**REQUEST FOR QUOTATIONS**  
**W.G. Johnson Storage - Lunch Room Renovation**  
**RFQ#: Q24-98**  
**ADDENDUM #2**

The following questions and answers are hereby issued in response to the questions of prospective respondents. **Please note that certain information is removed from the respondents' questions in order to protect the respondent's identity.**

**Question #9**

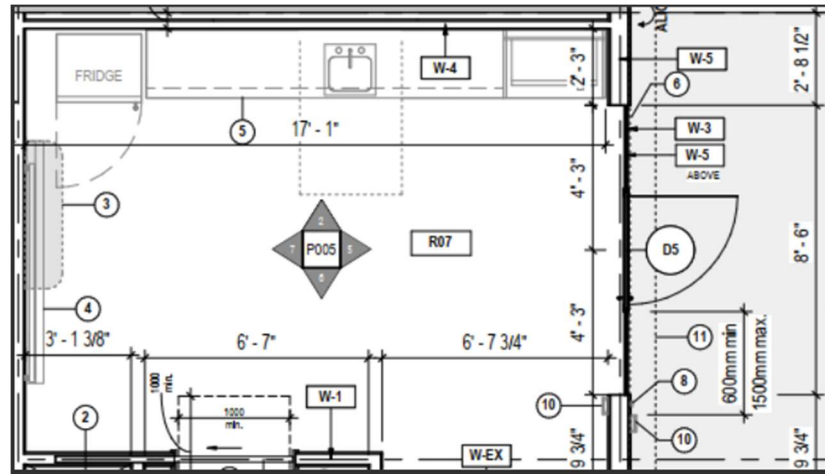
Can you please confirm ADO's required? Door schedule below shows ADO's for D3 and D5. However, I cannot locate D3 on drawings. Please confirm if only D5 requires ADO?

The only new power door operator is on D5. D3 is an existing door outside the scope of this renovation. Please disregard D3 on the door schedule.
